Gillig Low Floor Bus Front Axle Rod Removal and Installation Procedures

It has been discovered that a small percentage of torque rod cast clamps have been cast improperly, which could result in the breakage of clamps when initially torqued. As a precaution, all torque rods with cast clamps installed on vehicles since January 2004 are being replaced with a torque rods using a clamp of a different design. The following will provide instructions on how to identify the recalled torque rods. Also outlined is the procedure for the replacement of recalled rods.

Figure 1: Clamp Identification Aid

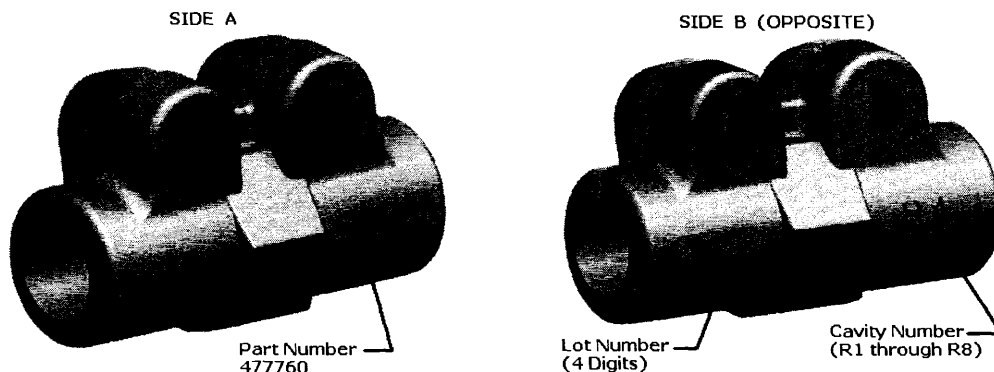
After the bus is put on a lift where the rods can be easily accessed and inspected, the suspect clamps can be identified as noted in the attached photo (Figure 1).

Figure 2: Identification Aid for Clamps Not Included in the Recall

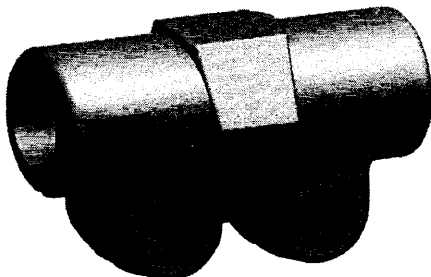
Not included in the recall are rods with clamps having the part number 477762 cast in them. These clamps can also be identified with a cavity number ending in the letter S and a 4 digit numerical lot number. Unlike the recalled clamps, these clamps will have all of the identification marking cast into the part on the same side. See Figure 2

Figure 3: Procedure to adjust new rod to length of removed rod.

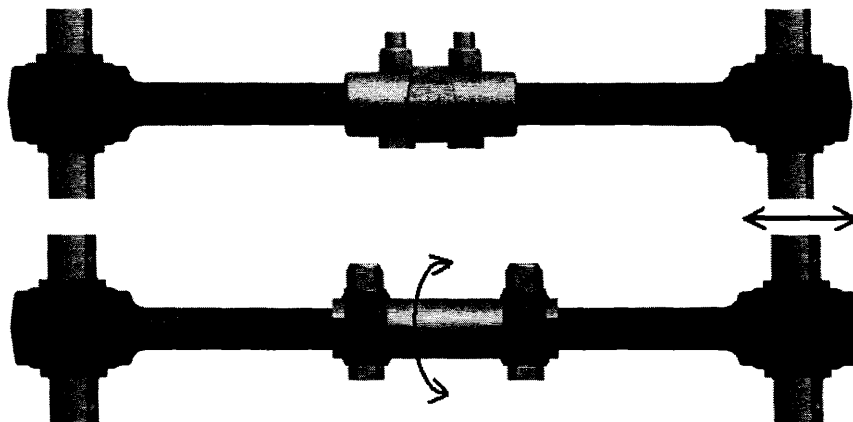
Note the new rod utilizes a clamp design with a machined center spacer with individual clamps on each end. Adjust the replacement rod to the same length as the removed rod by rotating the center spacer, not the rod ends. This procedure will assure that the bus alignment is maintained.

- Replacement rods will need to be adjusted to the same length as the rod it is replacing.
- Replacement rods clamps are tightened to a low torque for shipping. Loosen clamps before adjusting.
- Adjust the replacement rod by turning the clamp spacer, **not the rod ends**, until it is equal in length to the removed rod (See figure 3).
